**SYDNEY CENTRAL CITY PLANNING PANEL**

**COUNCIL ASSESSMENT REPORT**

<b>Panel Reference</b>	2018SWC077
<b>DA Number</b>	DA/376/2018
<b>LGA</b>	City of Parramatta
<b>Proposed Development</b>	Section 4.55(2) Modification to the approved construction of two 5 storey Residential Flat Buildings over basement car parking (DA/1165/2014 – Hornsby Shire Council). Modifications include alterations and additions to the approved plans resulting in 2 additional apartments, minor increase to the approved height and reduction in number of adaptable apartments from 27 to 9. The application is to be determined by the Sydney Central City Planning Panel.
<b>Street Address</b>	Nos.2 - 4 Crandon Road and Nos.35 - 39 Essex, EPPING NSW 2121 (Lots 1, 2, 3 & 6, DP 15049 and Lot 7, DP 655534)
<b>Applicant</b>	EQ Constructions
<b>Owner</b>	HIFU Enterprise Pty Ltd
<b>Date of DA lodgement</b>	14 November 2016
<b>Number of Submissions</b>	One submission
<b>Recommendation</b>	Approval, subject to conditions

**Figure 5- Building height- Building A- approved and proposed**

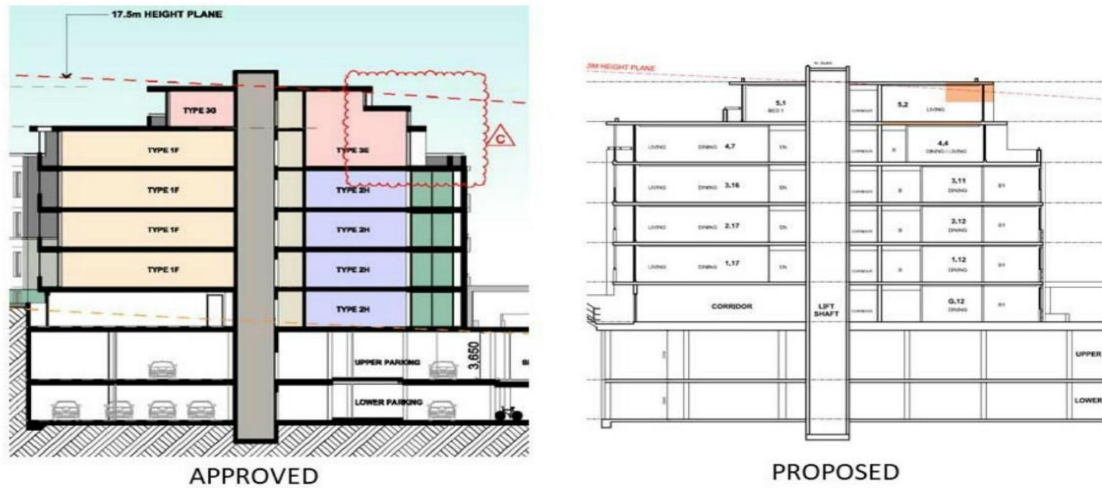
The proposed modification includes a small extension of the roof form of Building A to accommodate a part of Apartment 5.2, with a maximum height of 18.45m, which exceeds the 17.5m height control in this section by 0.95 metres, which exceeds the overall approved roofline by 150mm for Building A.

The proposed modification to the height relates to a small extension of the roof form of Building A to accommodate part Apartment 5.2, which seeks to increase the approved height by 150mm. and the overall roof exceeds the height control by 0.95 metres, with a maximum height of 18.45m, which equates to a 5.42% variation to the height standard.

- The additional storey to Building A will increase the height to more than 5 stories and the additional height is not compatible with the character of the area.

The proposed increase in building height is relatively minor and would not alter the approved bulk and scale, visual quality, streetscape or residential amenity. Accordingly, the non-compliance with the maximum building height is acceptable.

The proposed modification would increase the overall approved height of Building A by 150mm and no increase to the approved height of Building B. Whilst technically the proposed development result in a part 6 storey development due to apartment 5.2, however it is noted that this is within the approved void and upper floor areas with a minor extension to the approved roof line.

The proposed increase in building height is relatively minor and would not alter the approved bulk and scale, visual quality, streetscape or residential amenity. Accordingly, the non-compliance with the maximum building height is acceptable.
